CLINTON CSO STORAGE FACILITY PROJECT

CONTRACT NO. 7
BID REFERENCE NO. 7234
PROJECT NO. 587960

COUNTY OF ONONDAGA
DEPARTMENT OF WATER ENVIRONMENT PROTECTION
TOM RHOADS, P.E., COMMISSIONER

RECORD DRAWING

OVERFLOW CHANNEL - PLAN
SCALE: 1"=10'

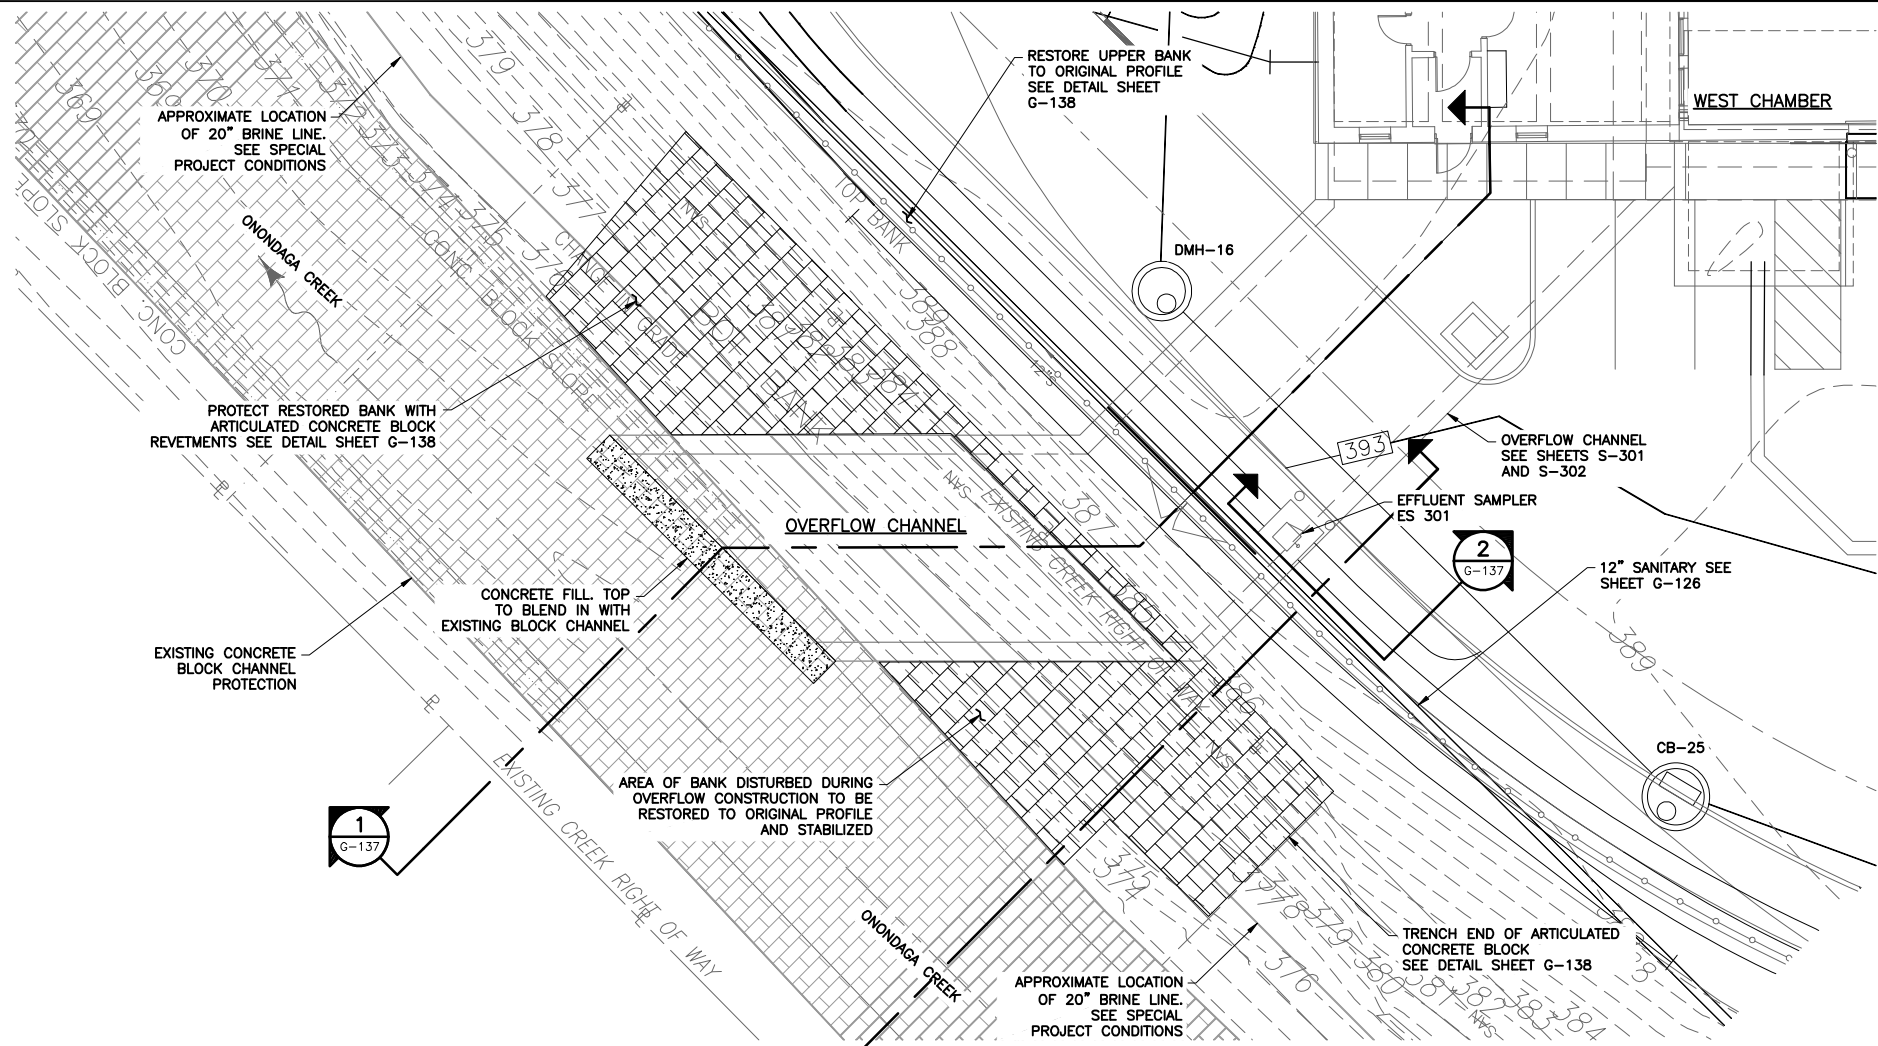
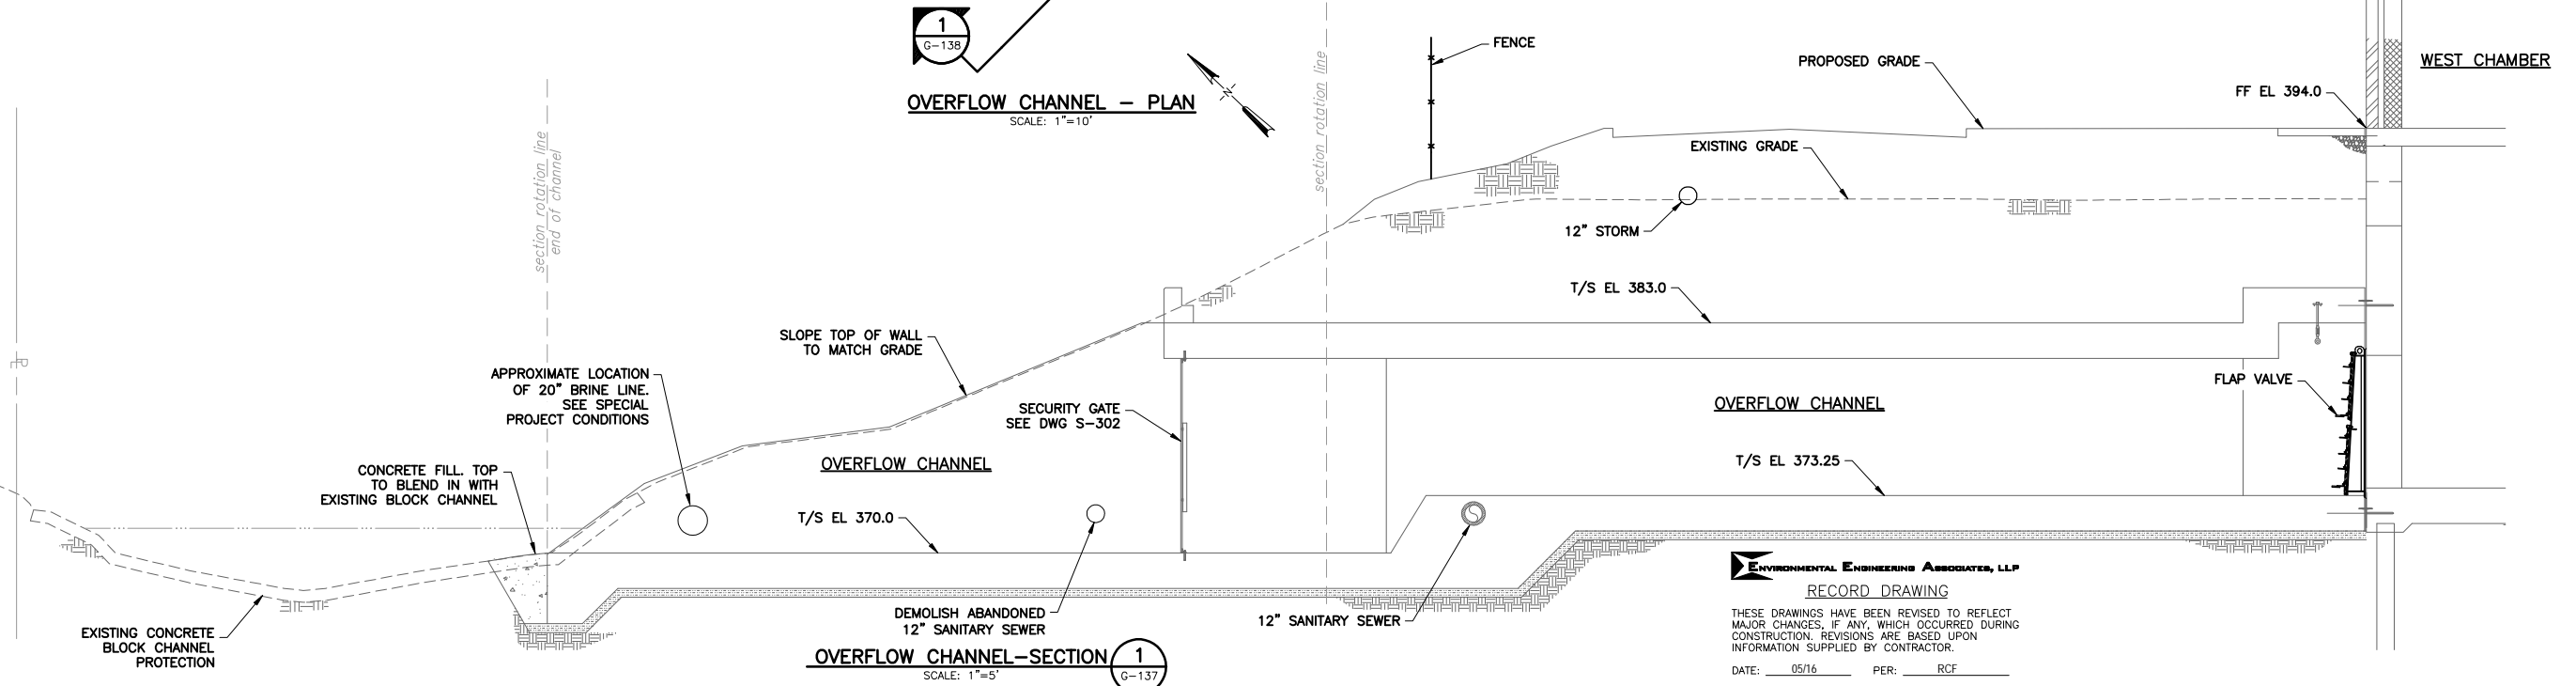
PROVIDE THE SPECIFICATION OF THE CONCRETE LINING AND GROUTED RIP RAP.

PROVIDE MORE DETAIL, INCLUDING PLANS AND SECTIONS, SHOWING HOW THE CONCRETE CREEK LINING AND GROUTED RIP RAP ARE TO BE CONSTRUCTED AND TIED INTO THE EXISTING BANK AND HOW THEY WILL BE TIED-IN BELOW THE WATER LINE.
